# SERVICE BULLETIN

SERVICE BULLETIN AR 3201 - 3/92

SUBJECT : Synthesizer Modules AR 3201

Synthesizer Module 28110 - 13000.000  
Synthesizer Module 28141 - 13000.000

Fig 1: Location of battery Bat. 3051 on Synthesizer Module 28110 - 13000.000

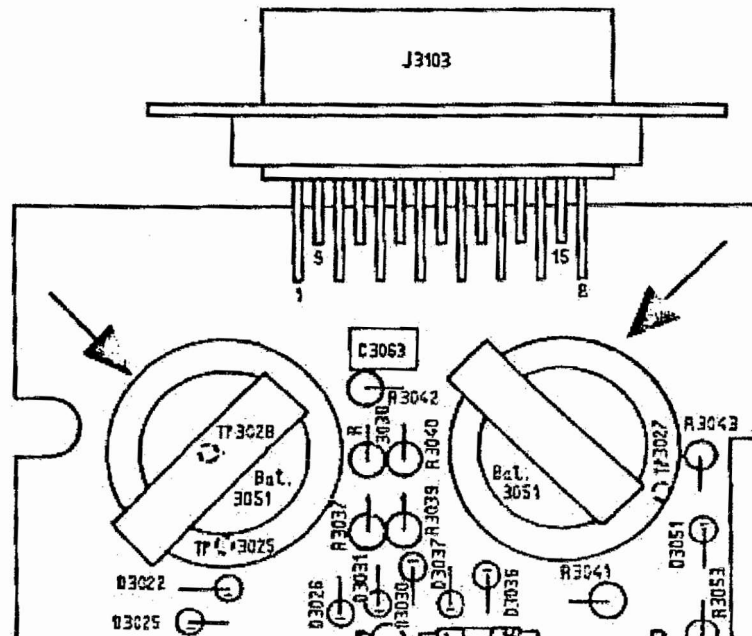
1. Determine manufacturing date of the Ni/Cd-battery. Since 1986 there is a marking on the battery's label (Bat. 3051 and Bat. 3052 or Bat 3001) which describes the manufacturing date.  
For example : 8707 means manufacturing date: 7th calendar week 1987
2. If the batteries are more than 4 years old it is recommended to replace the batteries, even if there is no visible damage.
3. Carefully check the battery connectors and the surrounding components for sediments
4. If there are any damages, remove the battery and surrounding components in order to get access to the contaminated printed conductors for cleaning. Use alcohol (methyl alcohol 94%) and a glass-brush for cleaning. Any component removed should be replaced with a new part.
5. If battery replacement is necessary, insert and solder new batteries as shown in Figures 1 to Figure 5. Ensure correct polarity!
